DOC21/619628

### **EPA Advice on Submissions Report**

Thank you for the request for advice from Public Authority Consultation (PAE-13876507), requesting the review by the NSW Environment Protection Authority (EPA) of the Submissions Report for the proposed Mount Pleasant Optimisation Project (Application SSD 10418), located 3 kilometres north west of Muswellbrook in the Upper Hunter Valley of New South Wales.

Figure 2: Timeseries graph showing effect of implementation of reactive measures

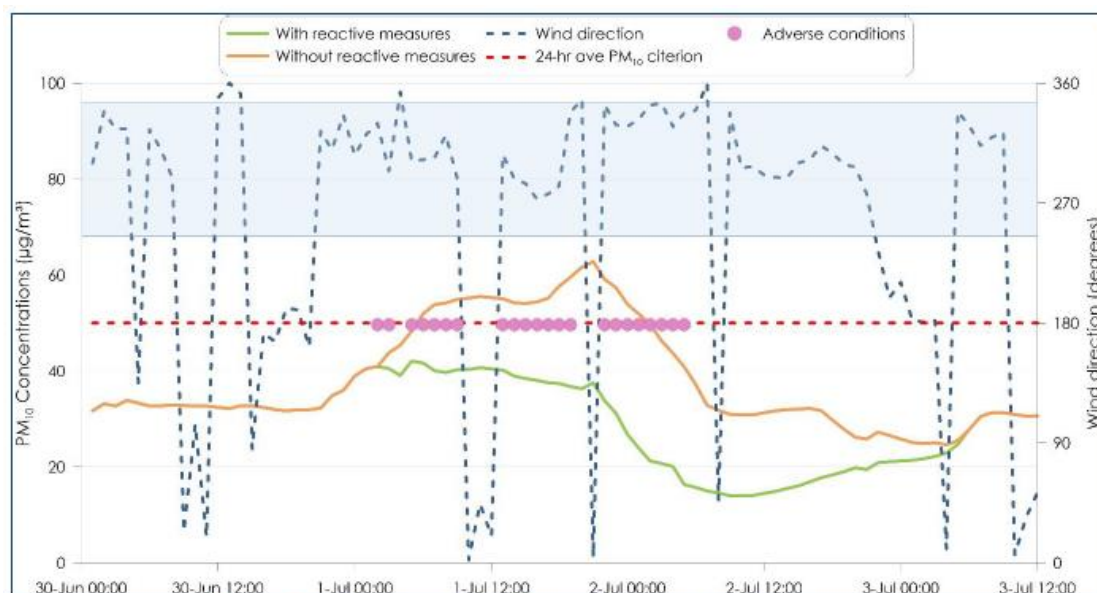
Further, there is no clarity in the Submissions Report around what was modelled and therefore what the actual trigger levels ( $PM_{10}$  concentration and wind direction) and actions (activities shutdown). This is in part due to the contradictory information provided. For example, Figure 2 of the timeseries of the effect of the reactive measures at receptor 112 appears to be applied prior to the  $PM_{10}$  concentration reaching  $44 \mu\text{g}/\text{m}^3$  (the stop work trigger contained in the EPL). This implies that an alternative trigger has been represented in the modelling, which may be the additional triggers in the AQMP. However, these additional triggers and management responses have not been included or described.

Further, the Submissions Report states the pink spots in Figure 2 indicate the hours in which the adverse triggers activate at the  $50 \mu\text{g}/\text{m}^3$  level. This implies that an additional reactive management trigger has been considered and represented in the additional modelling. As receptor 112 is closest to the Muswellbrook NW monitor, the EPL condition applies ( $44 \mu\text{g}/\text{m}^3$  at

Muswellbrook NW monitor). If a lower trigger concentration at Muswellbrook NW is required to effectively manage impacts at Muswellbrook, the proponent should clearly identify this.

***The EPA recommends that the proponent identifies the specific triggers and specific actions that are modelled and therefore proposed to be used to manage particulate emissions and impacts at the affected receptors, both for Muswellbrook and isolated receptors, to demonstrate they will be able to manage the particulate emissions and impacts.***
